# United States Patent and Trademark Office

APPLICATION NO.	FILING DATE	FIRST NAMED INVENTOR	ATTORNEY DOCKET NO.	CONFIRMATION NO.
09/779,169	02/08/2001	Eric P. Orgeron	A99274US (98062.3)	6510
22920	7590 04/10/2002			
GARVEY SMITH NEHRBASS & DOODY, LLC THREE LAKEWAY CENTER 3838 NORTH CAUSEWAY BLVD., SUITE 3290			EXAMINER	
			PIASCIK, SUSAN L	
METAIRIE, L	A 70002		ART UNIT	PAPER NUMBER
			3643

#### **DETAILED ACTION**

# FIGURE 1

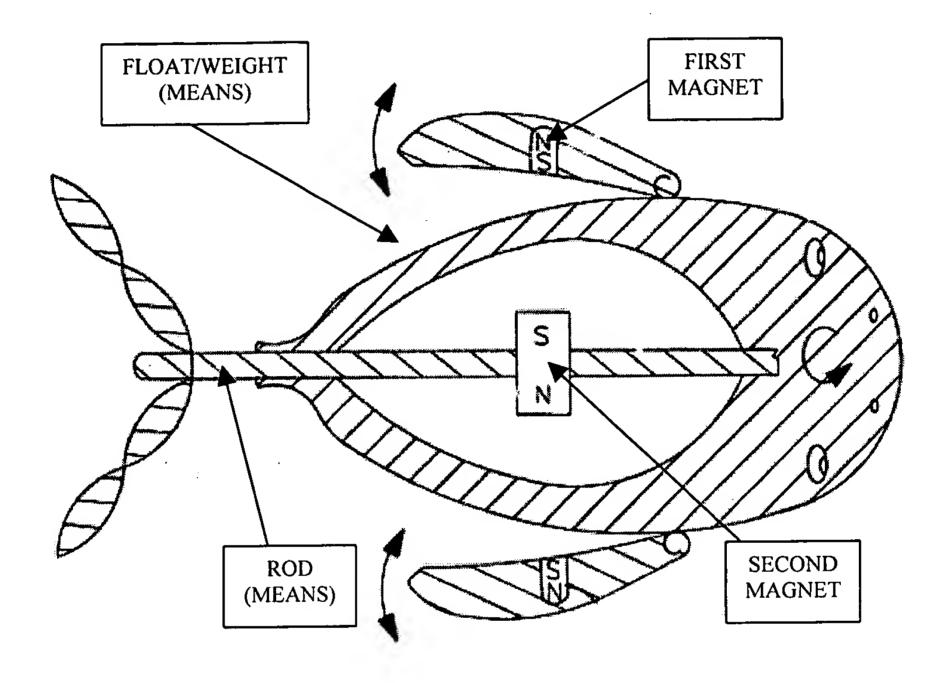
Claim 9 is rejected under 35 U.S.C. 102(e) as being clearly anticipated by Preston.

In regards to **claim 9**, Preston teaches an apparatus for making a sound similar to the slapping or clicking noise that a live shrimp makes when the tail section of the live shrimp makes contact with its body section comprising: a float (11) slidably received on a rod (16), a first magnet (24) attached to the float (11) and a second magnet (14) attached to the rod (16). The first (24) and second (14) magnets are aligned such that they repel one another (see col 2, lines 52-55). See Figure 1 below.

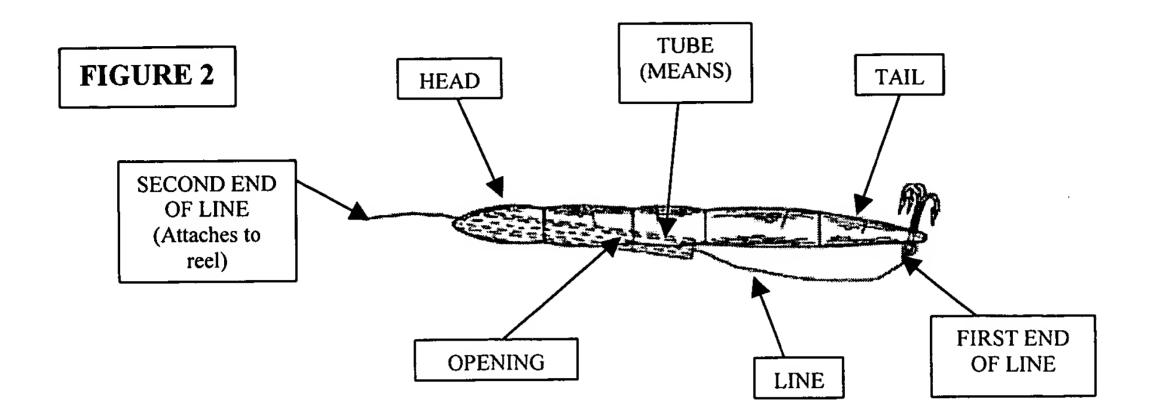
Claims 18-24, 26-27, 31-34 and 39-40 are rejected under 35 U.S.C. 102(b) as being clearly anticipated by Brokaw.

In regards to **claim 18**, Brokaw teaches a fishing lure (2c) comprising an artificial bait body (unnumbered) having a tail (10) and an opening (50) in the body for allowing a line (14) to pass from the tail (10) of the artificial bait body (unnumbered) through the opening (50). See Figure 2 below.

In regards to **claim 20**, Brokaw teaches a fishing lure (2c) wherein the artificial bait body (unnumbered) has a head (8). The lure (2c) also has an opening (50) in the artificial bait body (unnumbered) positioned forward of the tail (10), generally in between the head (8) and the tail (10). The lure further comprises a flexible fishing line (14) or leader having first and second ends (unnumbered). The first end of the fishing line (14) is attached to the tail (10) of the artificial bait body (unnumbered) and the line (14) passes through the opening (50) wherein the second end of the fishing line (14) is connected to a fishing reel or to a length of fishing line wound upon a reel. See Figure 2 above.

Regarding claim 26, Brokaw teaches a fishing lure (2c) wherein the artificial bait body (unnumbered) is an artificial shrimp body (see col 1, lines 30-34) and there is a tube means (unnumbered) in the opening (50) for allowing a line (14) to pass from the tail (10) of the artificial shrimp body through the tube means (unnumbered). See Figure 2 above.

In regards to **claim 31**, Brokaw teaches a fishing lure (2c) wherein the artificial bait body (unnumbered) is an artificial shrimp body (see col 1, lines 30-34) and there is a tube (unnumbered) in the opening (50) for allowing a line (14) to pass from the tail (10) of the artificial shrimp body through the tube (unnumbered). See Figure 2 above.

In regards to **claim 39**, Brokaw teaches a fishing lure (2c) further comprising a tube means (unnumbered) in the opening (50) for allowing a line (14) to pass from the tail (10) of the artificial bait body (unnumbered) through the tube means (unnumbered). See Figure 2 above.

In regards to **claim 40**, Brokaw teaches a fishing lure (2c) further comprising a line (14) passing from tail (10) of the artificial bait body (unnumbered) through the tube means (unnumbered). See Figure 2 above.
